ANGELO'S RECYCLED MATERIALS

RE: June 22, 2010 Site Inspection (Received via email August 31, 2010)
Response to FDEP Inspection Comments
Enterprise Class III Landfill
Angelo's Recycled Materials

WELL NUMBER: 12R

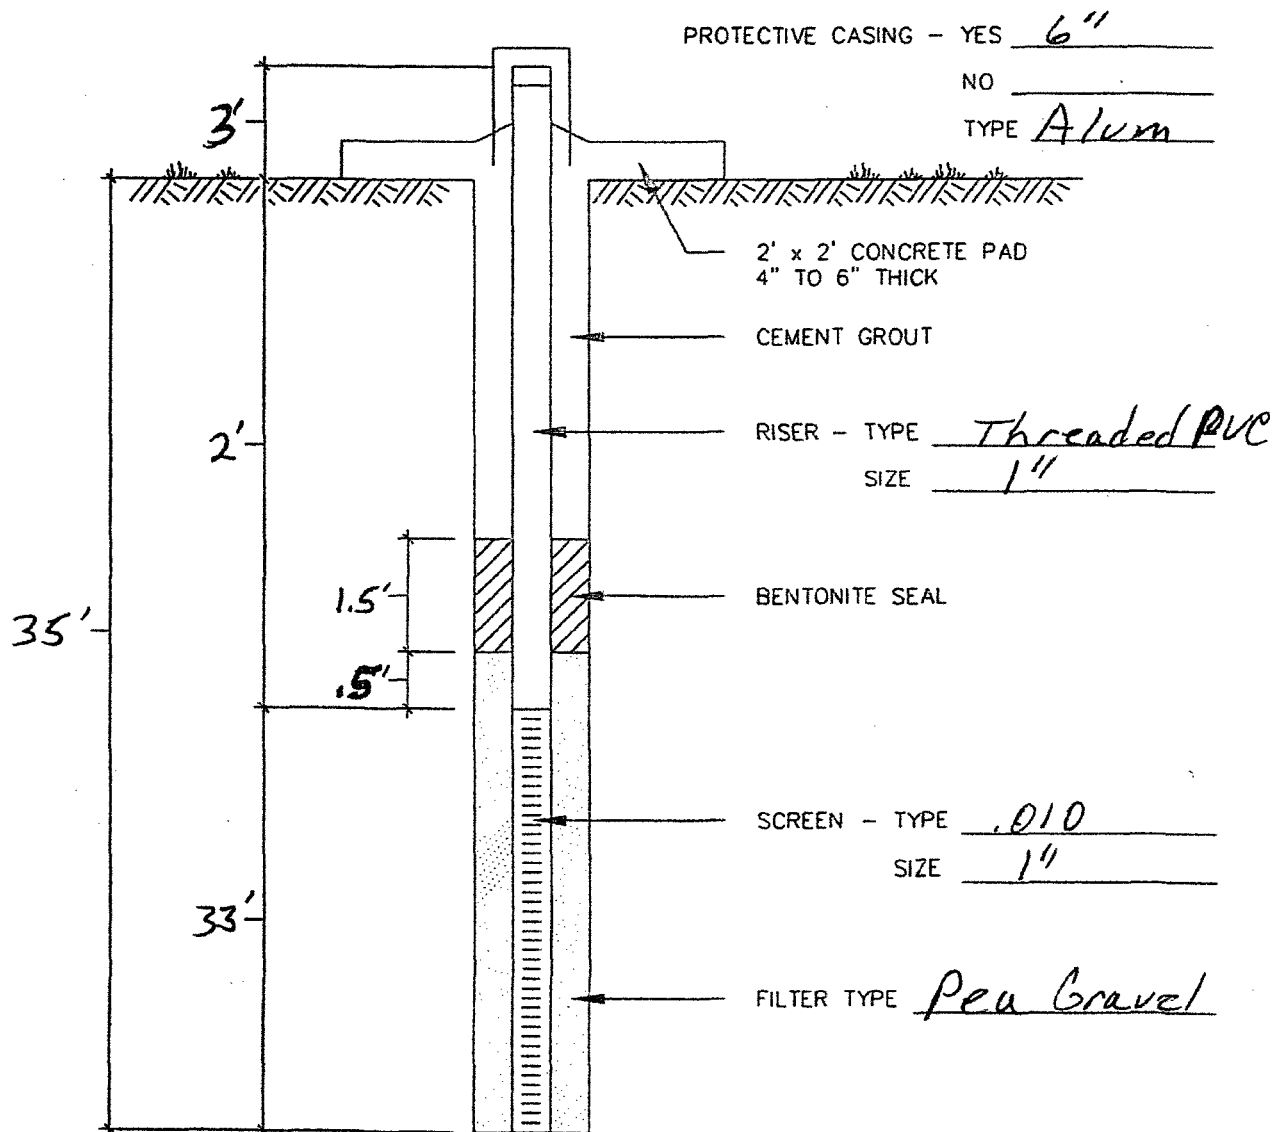
LFG concentrations recently reported for probes GP-12 and GP-13 have been above 100% of the Lower Explosive Limit (LEL). As a result, probes GP-12R and GP-13R were installed closer to the property boundary on September 16, 2009. A report of construction details for GP-12R and GP-13R was submitted to the Department on October 7, 2009.

This letter is to inform you that the proposed gas monitoring wells 12R and 13R have been constructed by Universal Engineering Sciences and the well completion logs are attached. Well locations were verified with a hand held GPS instrument. Sampling of these new wells will begin with the next monthly monitoring event. Monitoring will continue on a monthly basis. Provided there is sufficient data (in the future) to show that landfill gas at the property line does not exceed compliance standards, we will provide a written request to the Department to modify the sampling interval.

SITE MONITORING NETWORK

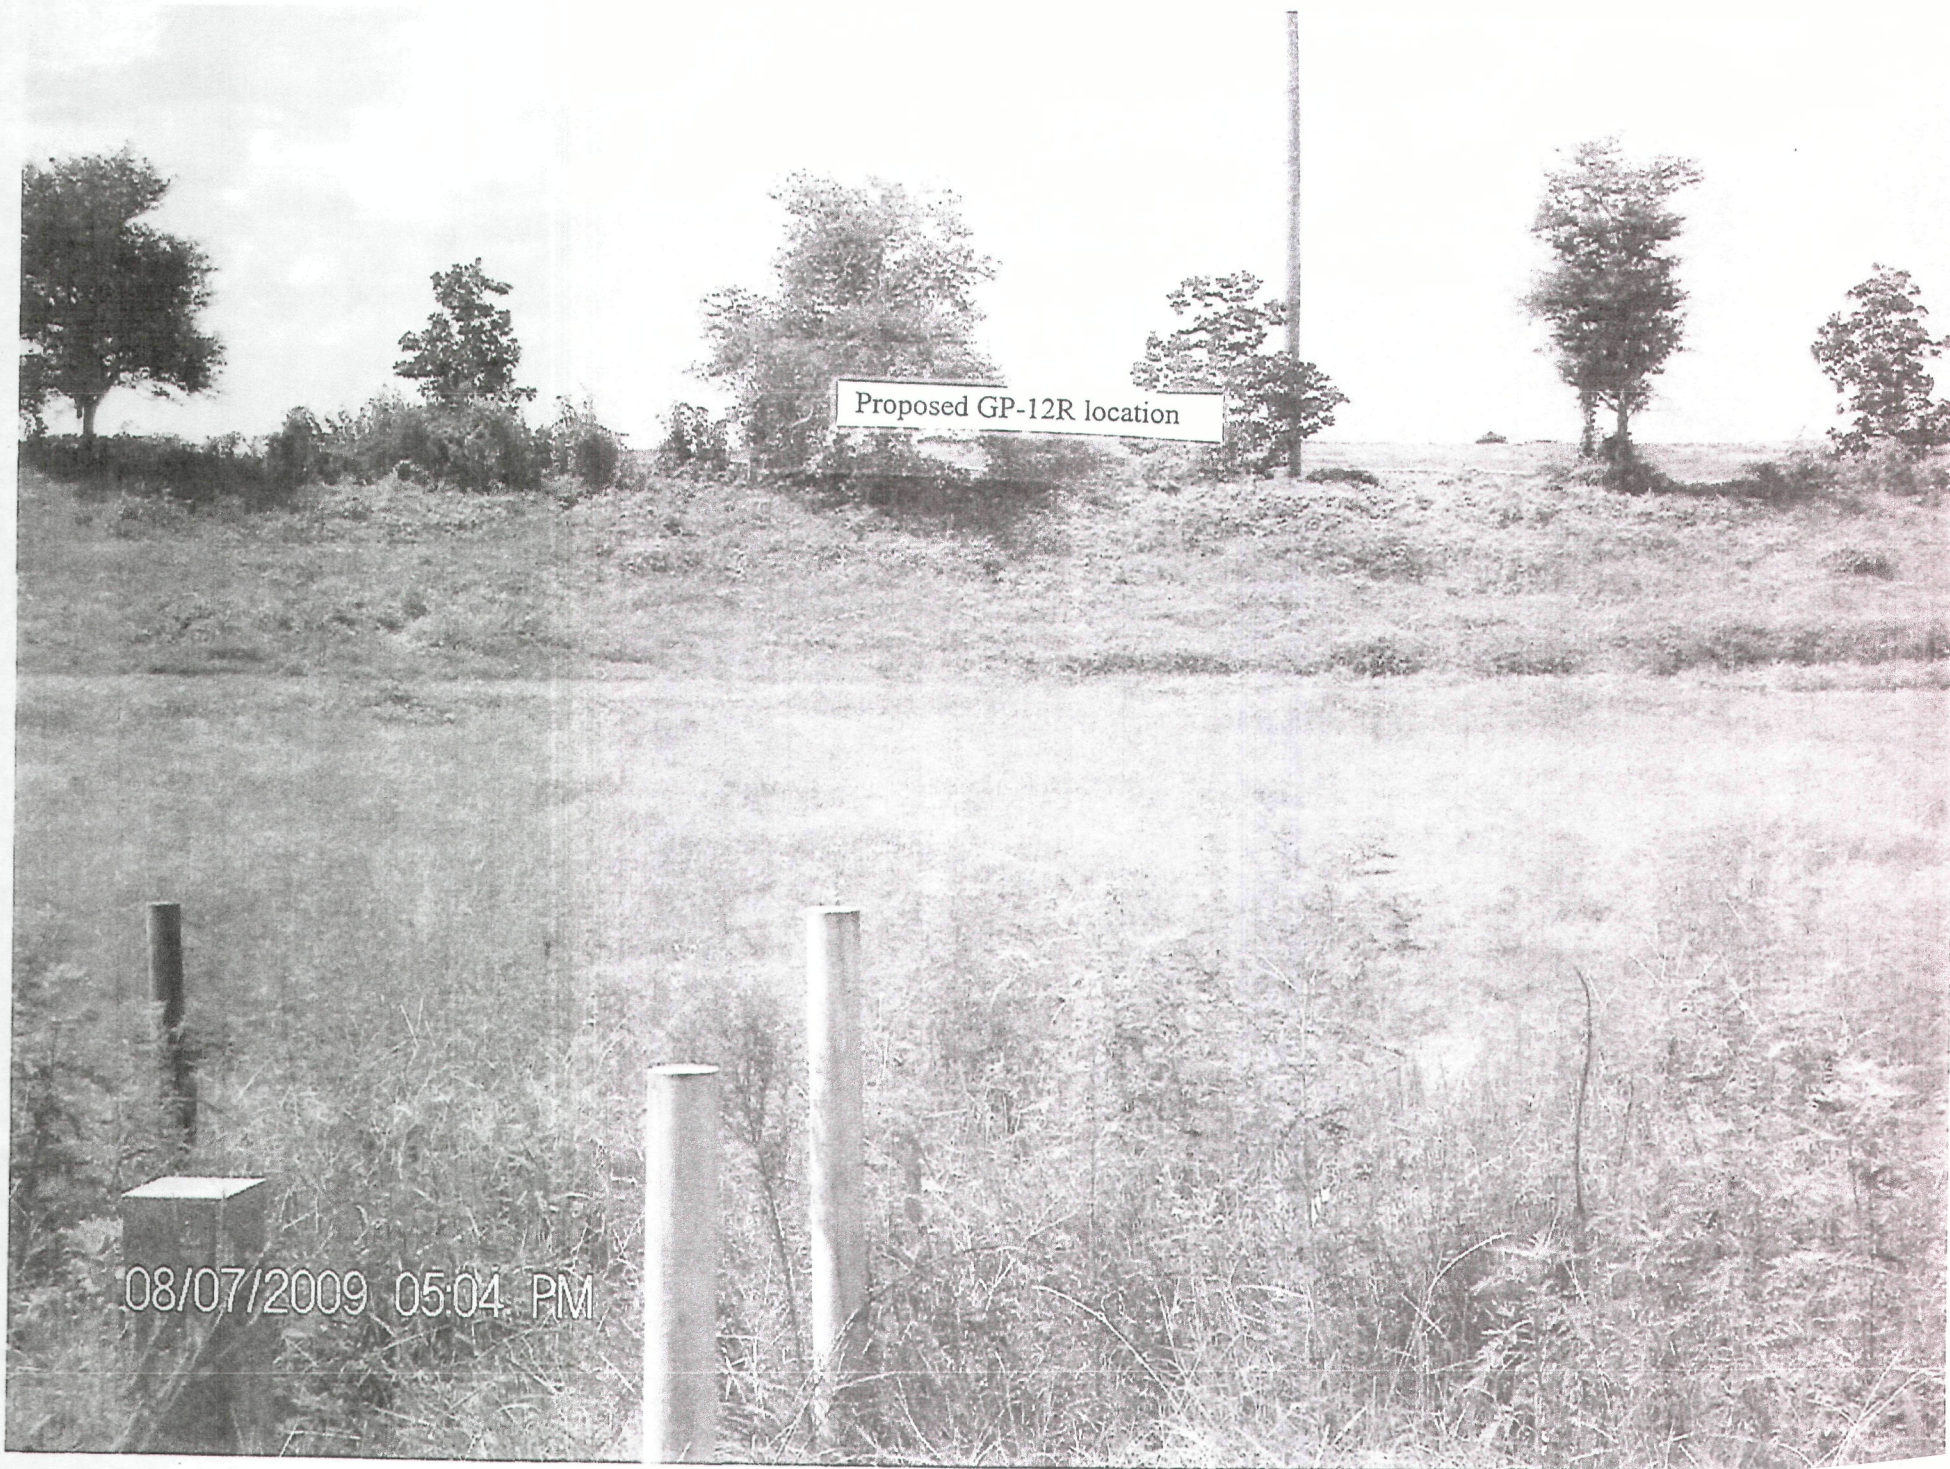
Department Comment #3

It appears that in order for the facility's gas monitoring system to comply with Rule 62-701.530(2)(b), F.A.C. and monitor the facility for compliance with Rule 62-701.530(1) (a), F.A.C. at the property line, additional permanent monitoring probes down gradient of GP-12 and GP-13 at or in closer proximity of the property line may need to be installed. Based on the results of the above investigation of gas levels down gradient of GP-12 and GP-13, please identify where replacement down gradient gas monitoring probes will be installed, along with proposed probe construction details (e.g. a typical gas monitoring probe detail with proposed well depths and screen intervals). Such proposed changes to the gas monitoring plan for the facility can be incorporated into the next facility permit modification.

Response to Comment #3

Two additional gas probes (GP-12R and GP-13R) are proposed to be installed at the locations shown in the attached site plan and photos. The new probes will be constructed to depths of approximately 20 feet below ground surface. The probes will be constructed of one-inch diameter PVC with 2 feet of solid PVC and 18 feet of slotted PVC.

Proposed GP-13R location
